#### FERGUSON TOWNSHIP PLANNING COMMISSION Regular Meeting Agenda Monday, April 11, 2022, 6:00 PM

SUBJECT: Tussey Tracks - Centre Animal Veterinary Hospital Preliminary Land Development Plan

SUBJECT: Center Animal Hospital Preliminary Land Development Plan 3rd Review

Management Site Plan Third Review (ES – 1117)

SITE LAYOUT PLAN

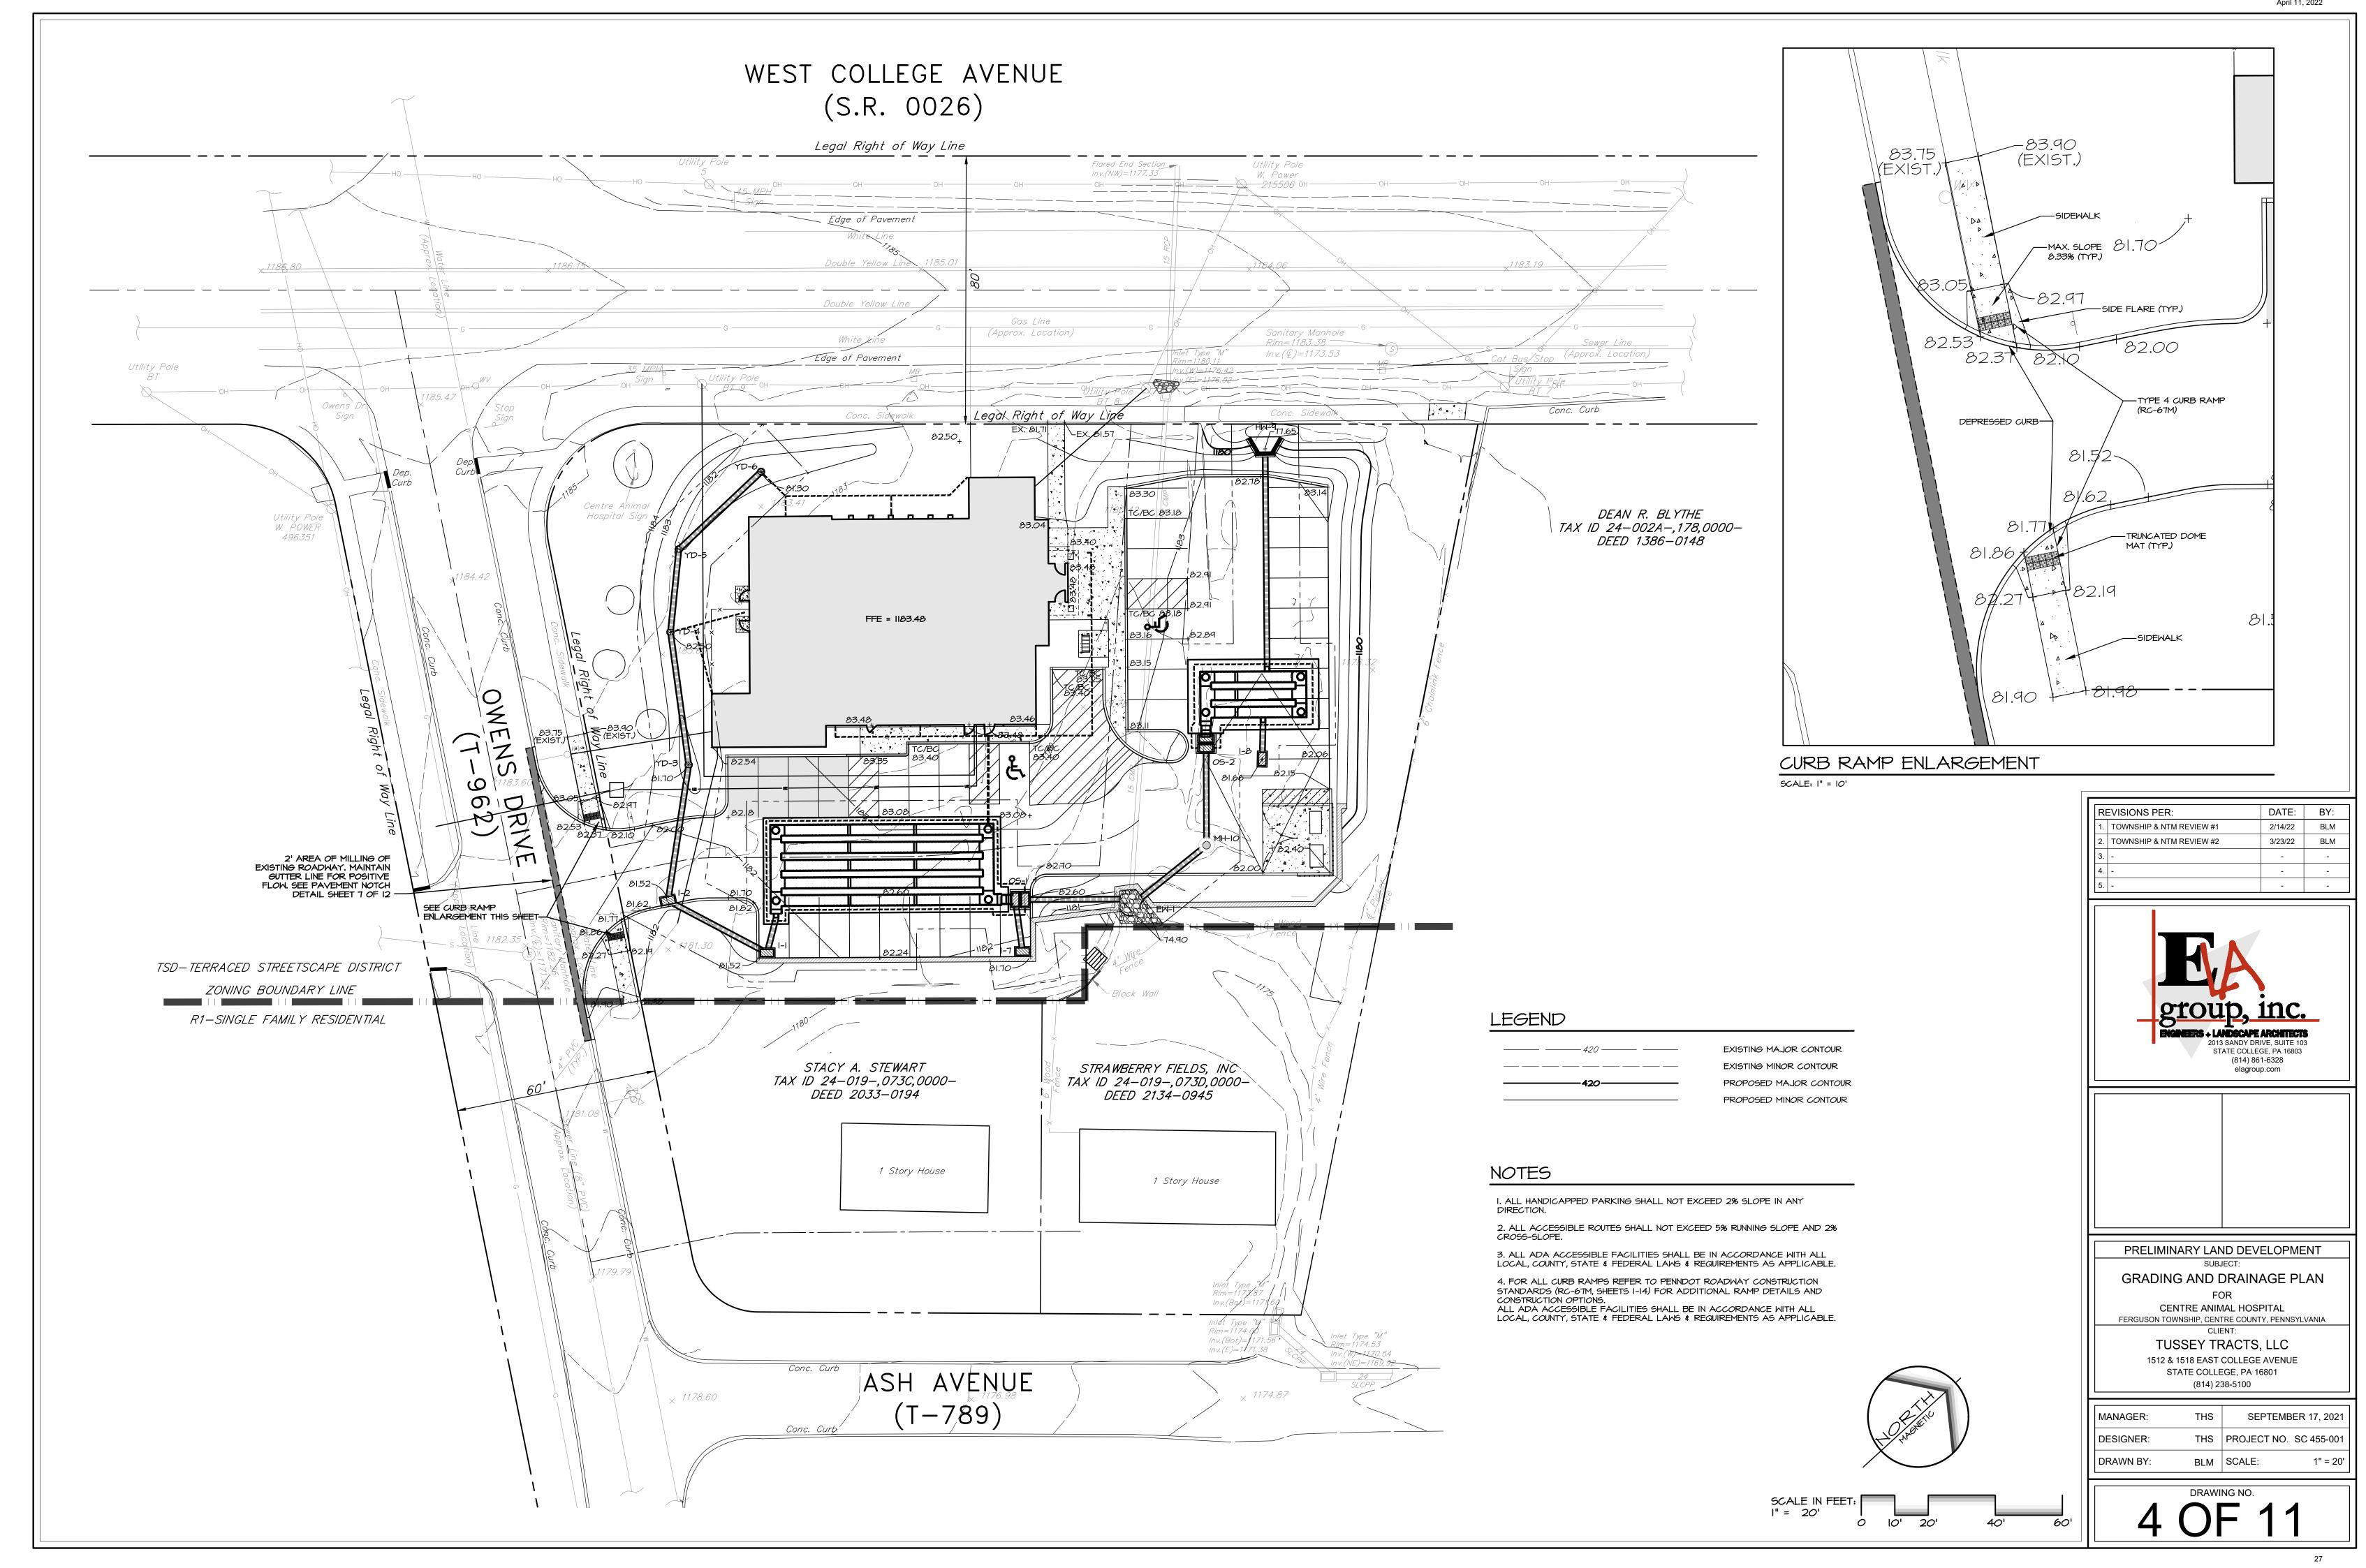
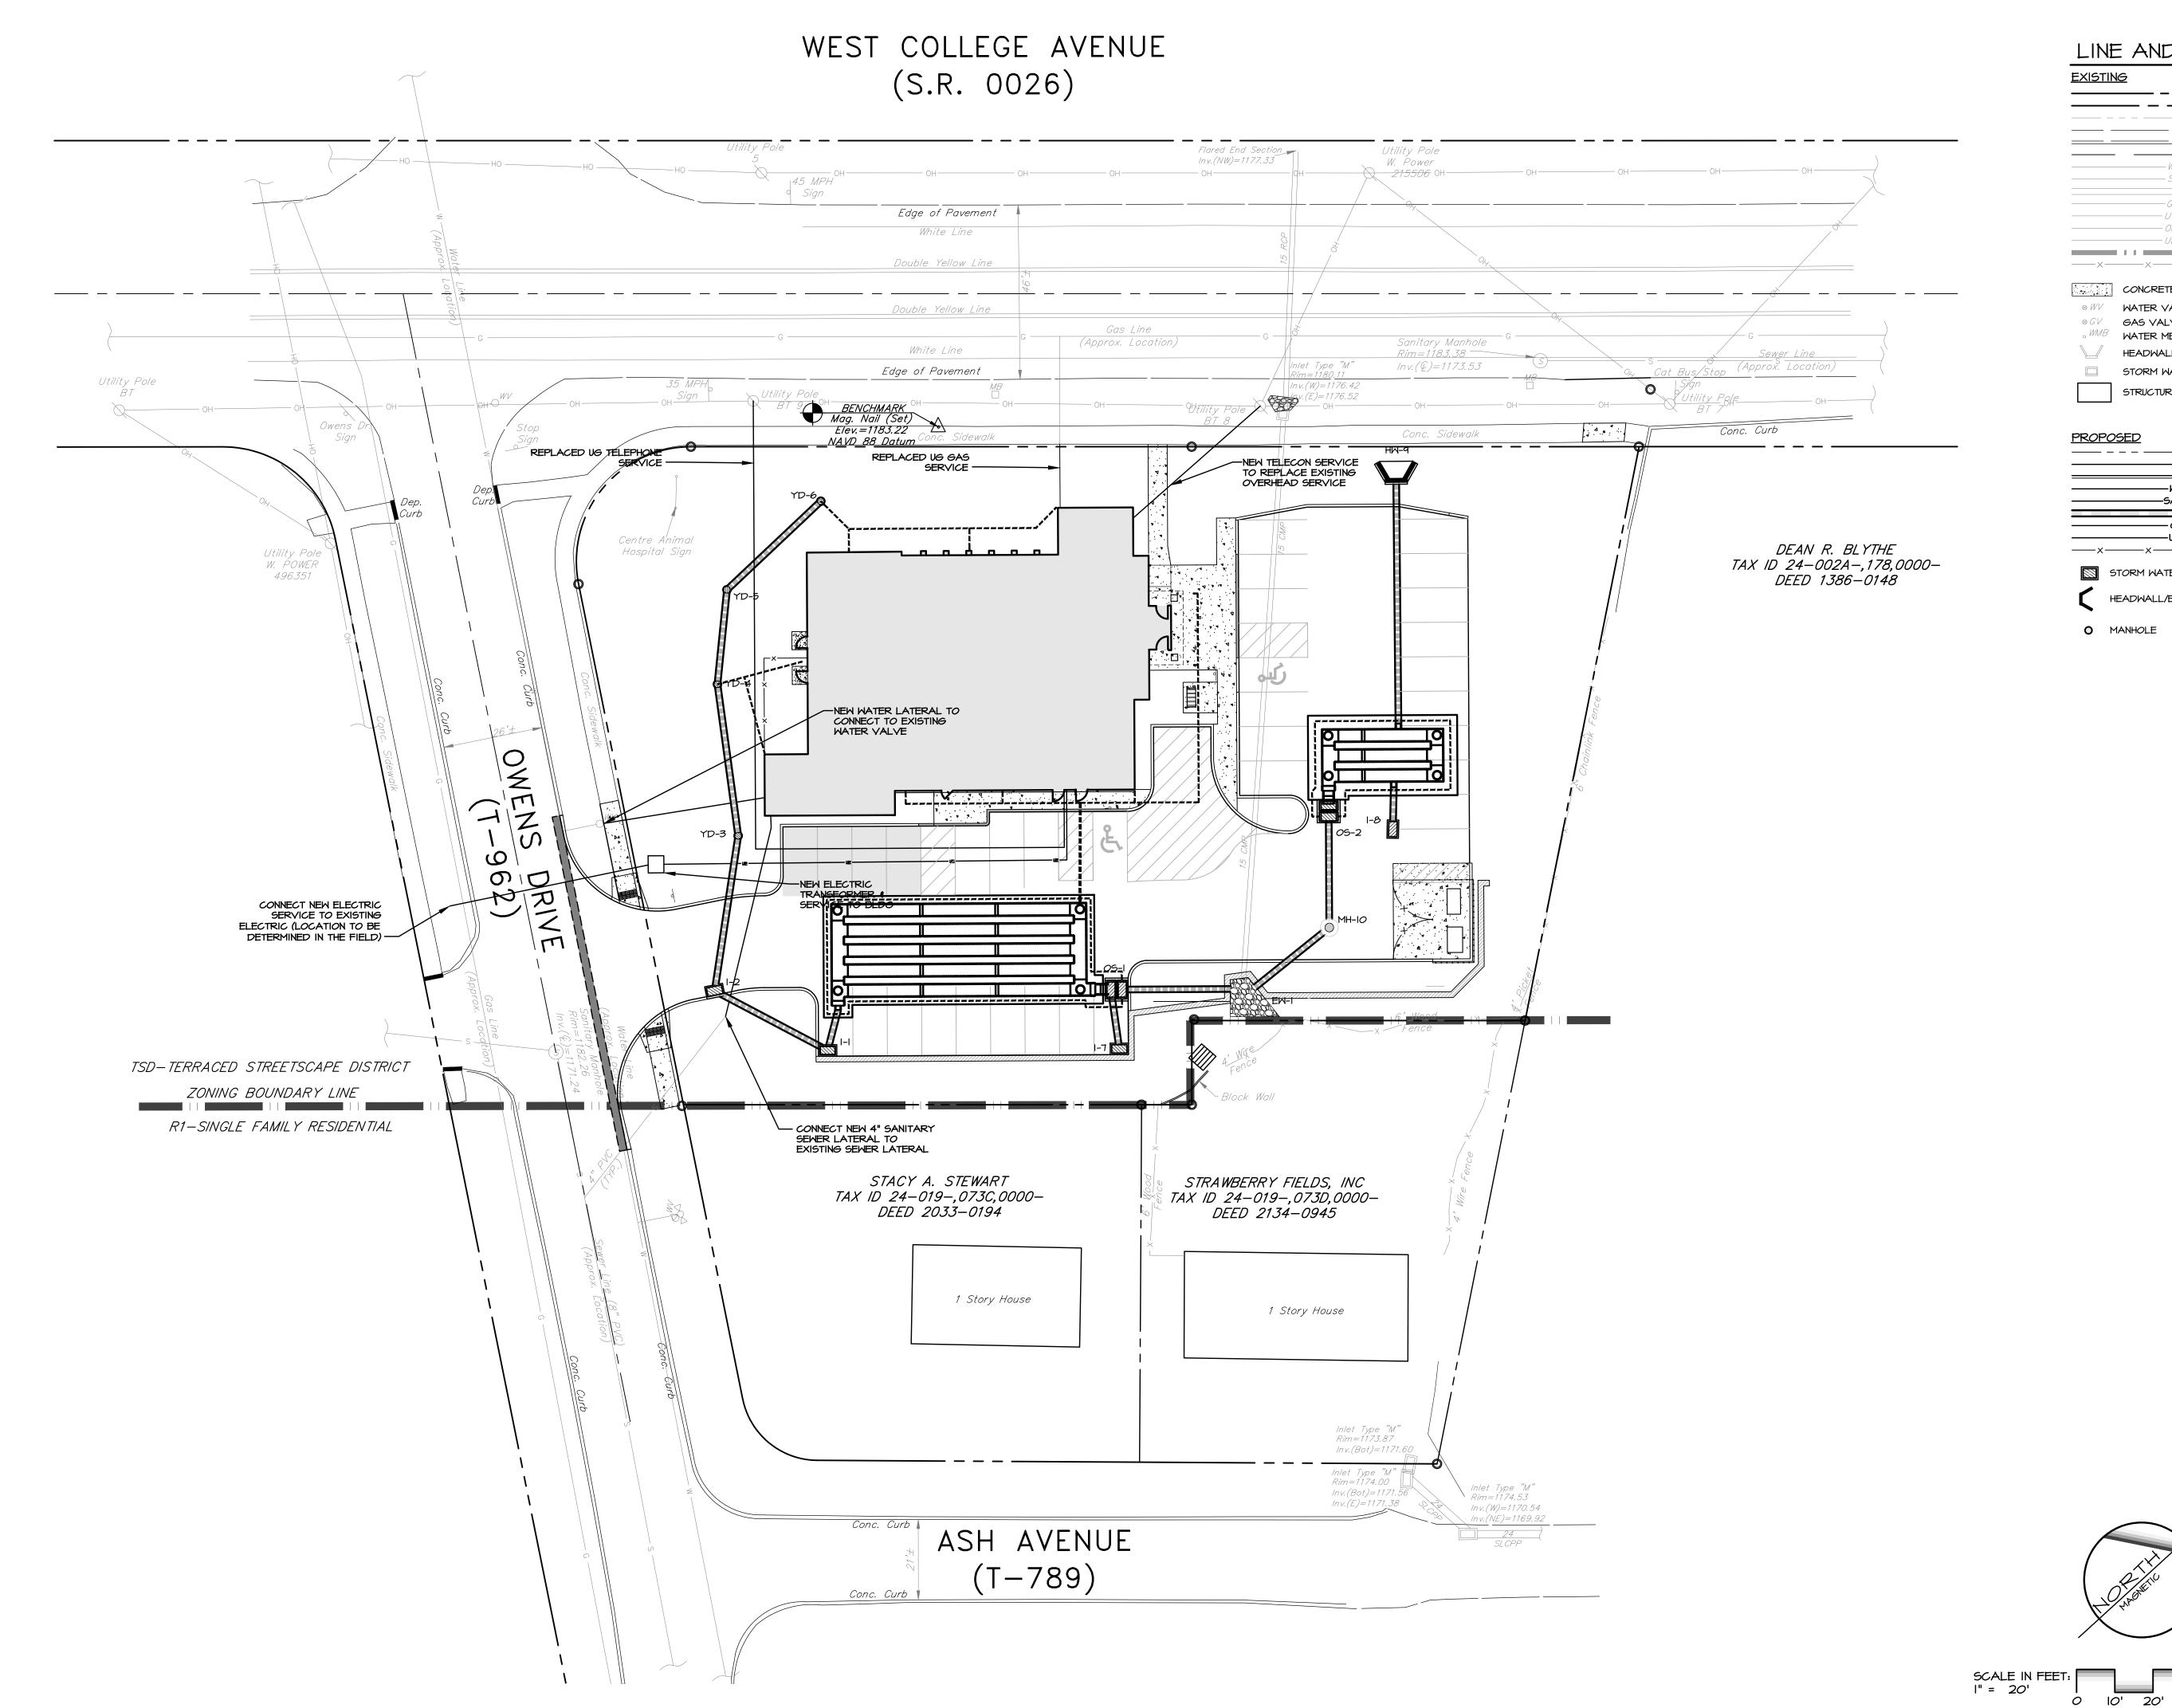
a. The plan depicts four pervious parking spaces, perhaps to meet maximum impervious coverage. The detail on Sheet 7 for Concrete Unit Paver does not provide a pervious design and is therefore not considered pervious. To get credit for being pervious, the underlying area needs to be designed as pervious to allow for infiltration and should be documented in the stormwater management site plan and report. Pending review of SWMSP.

SUBJECT: LIGHTING PLAN

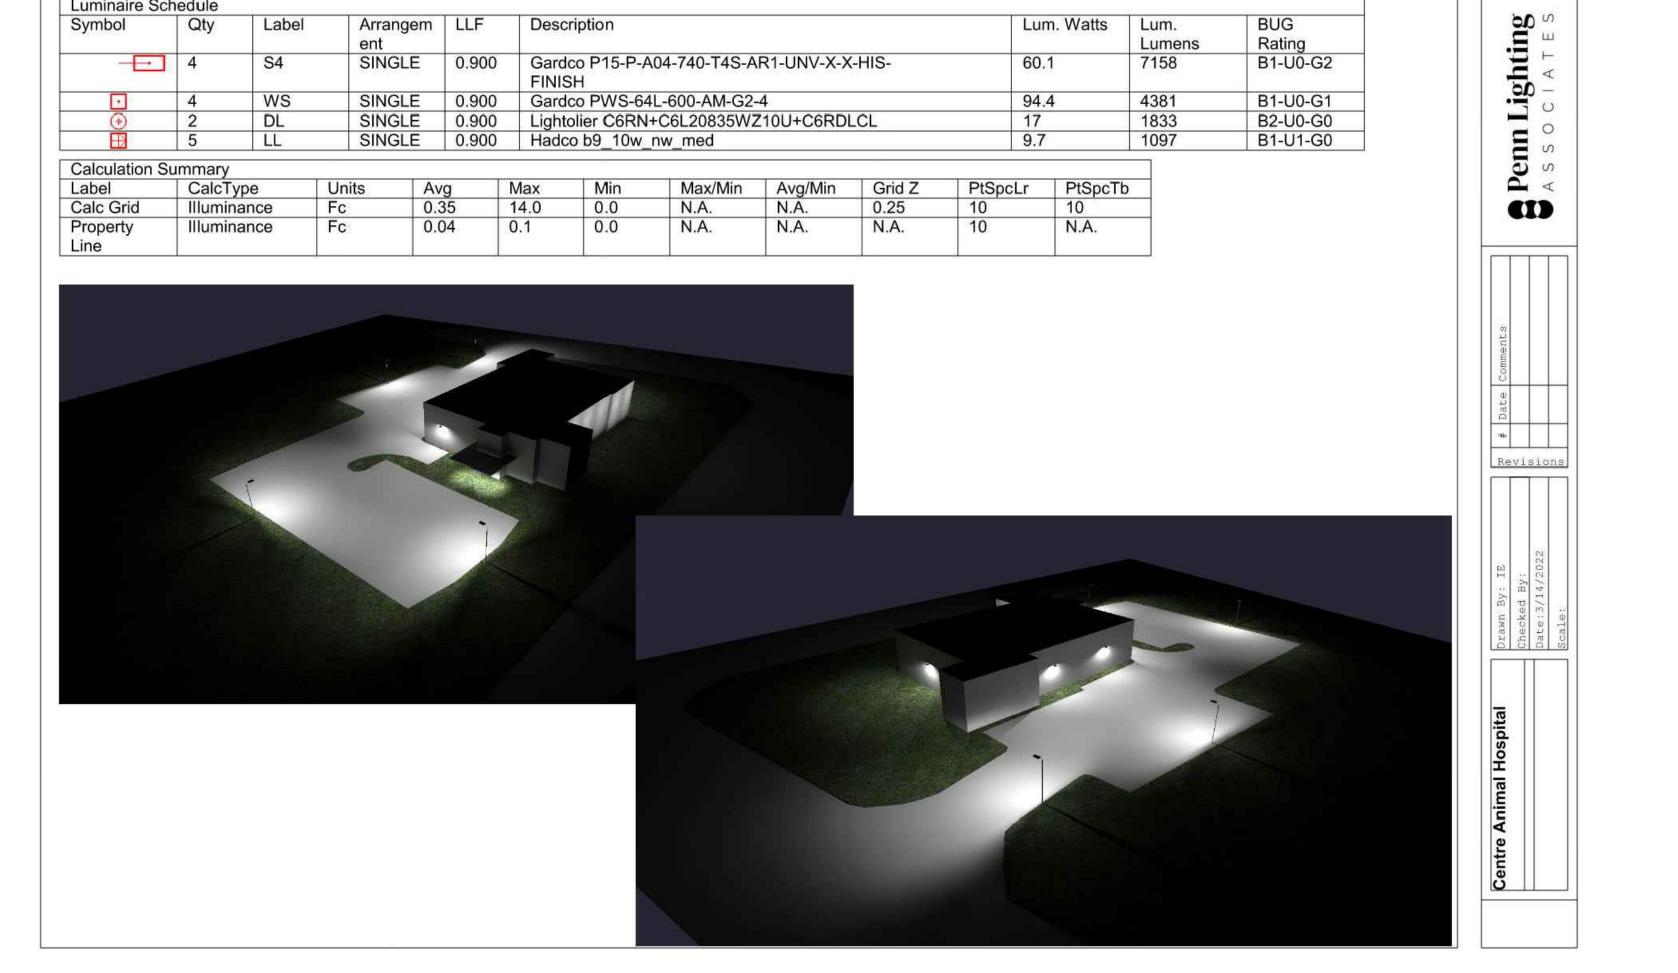
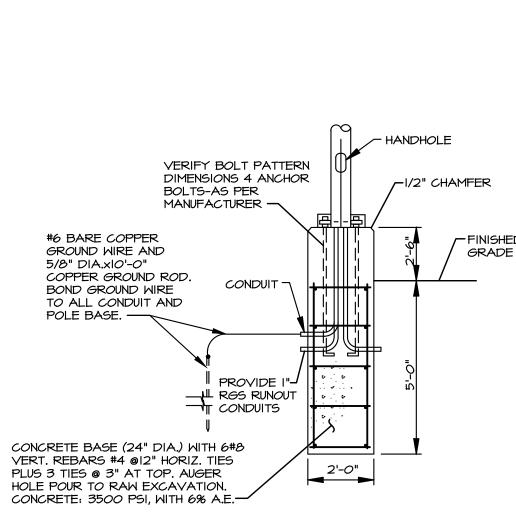
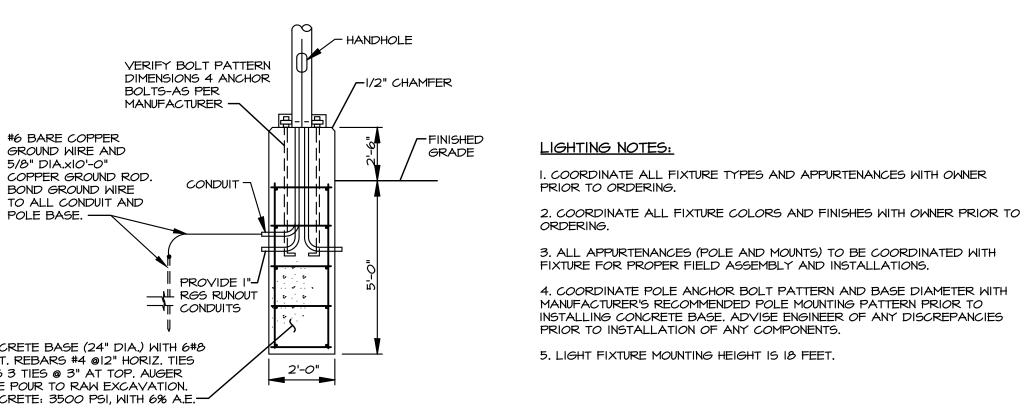
2. The lighting exceeds the allowable maximum maintained luminance levels along the rear property line as outlined in §4-127.C. of the Township ordinance requirements. Update the plans and resubmit.

April 5, 2022 Response: Comment addressed.
